REVISED RESPONSE TO REQUEST FOR ADDITIONAL INFORMATION**APR1400 Design Certification Review - 52-046****Korea Hydro & Nuclear Power Co., LTD****Docket No. 52-046****RAI No.: 264-8243****SRP Section: 06.02.05 – Combustible Gas Control in Containment****Application Section:****Date of RAI Issue: 10/22/2015**

Question No. 06.02.05-6

Figure 1 Schematic Diagram for ECSBS Check Valve

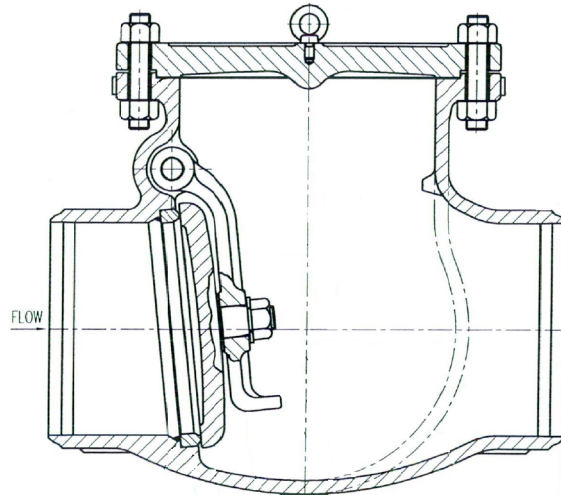
In the equipment survivability analysis described in DCD Tier 2, Section 19.2.3, credit is taken for maintaining the containment pressure below the factored load category of 123 psia, per DCD Tier 2, Section 19.2.4.2.3, by relying on the emergency containment spray backup system (ECSBS). See DCD Tier 2, Figure 19.1-3, Simplified Diagram – Containment Spray System. This is a single train system, with its own dedicated ECSBS spray ring header and an inside containment isolation check valve, V1014. This backup spray function is the basis provided for

limiting the equipment survivability analysis to 24 hrs, as stated in DCD Tier 2, Section 19.2.3.3.7.2, "Determination of Severe Accident Environmental Conditions." This valve should be shown to meet the equipment survivability conditions, including surviving a hydrogen burn and remaining open. This valve should be added to DCD Tier 2, Table 19.2.3-4.

The check valve has another function of water delivery to the ECSBS header during severe accidents. However, the ES evaluation of the check valve is the as same as piping its water delivery function to the ECSBS header, because of the following reasons:

- The check valve resists damage due to temperature increases because it consists of only metallic parts. The metallic parts resist thermal damage according due to the hydrogen burn or continuous temperature rise which results from decay heat.
- It is expected that the check valve continues to function due to its simple structure, as shown in Figure 1.

Therefore, it is not necessary to evaluate the survivability of check valve V1014, but the valve will be added to Table 19.2.3-4, as shown in Attachment 1 to this response. The discussion of the valve's resistance to thermal degradation will be relocated to a new section within 19.2.3.3.7.4 since the valve is not located outside containment which is the heading of the valve's current discussion.

Figure 19.1-3 Simplified Diagram - Containment Spray System

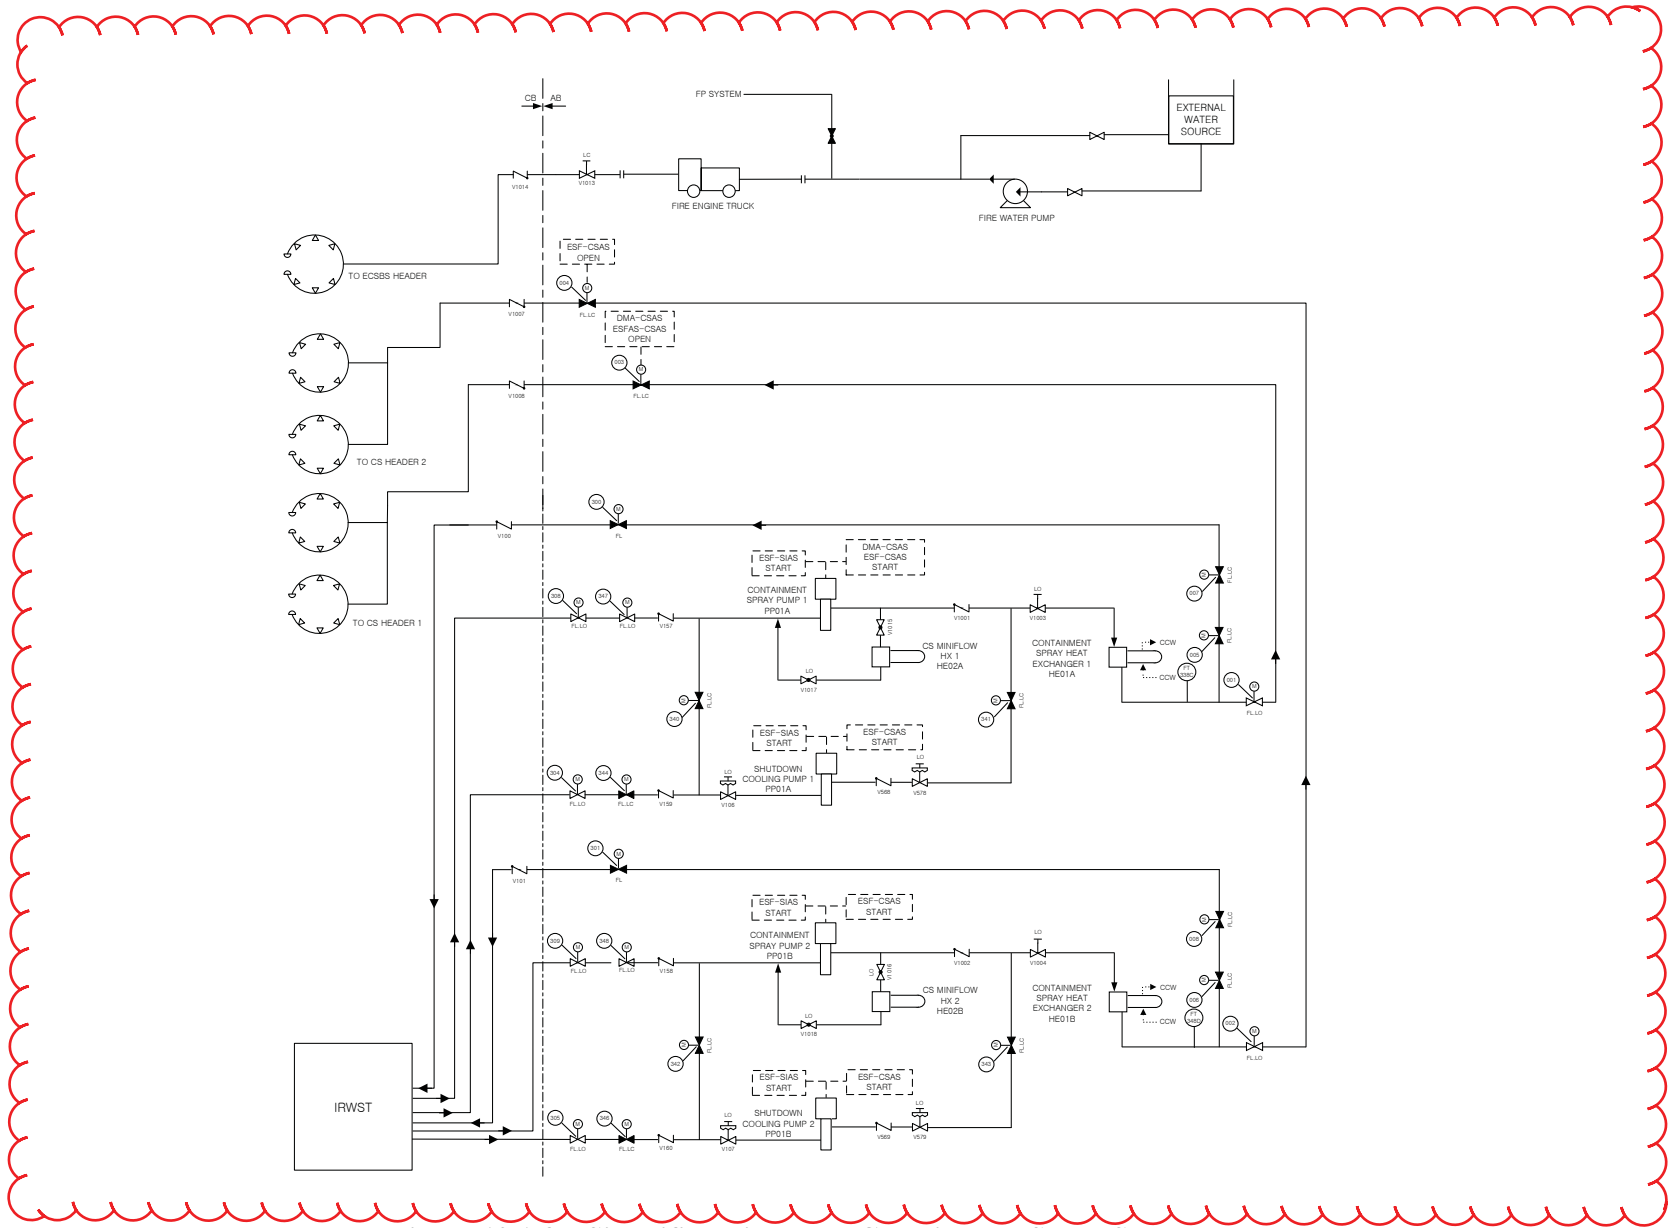
Please confirm that all of the check valves shown in DCD Figure 19.1-3, Simplified Diagram – Containment Spray System, are depicted correctly to indicate the direction of flow. Check valves V1014, V1008, and V1007 appear to be shown in an inconsistent direction as compared to V101 and V100. Adding flow direction arrows below the check valve symbol, as done in DCD Tier 2, Table 6.2.4-1, would provide clarification.

DCD Tier 2, Figure 19.1-3 will be revised to correct the directions of flow for check valves (V100, V101, V1007, V1008 and V1014), as shown in Attachment 2 to this response.
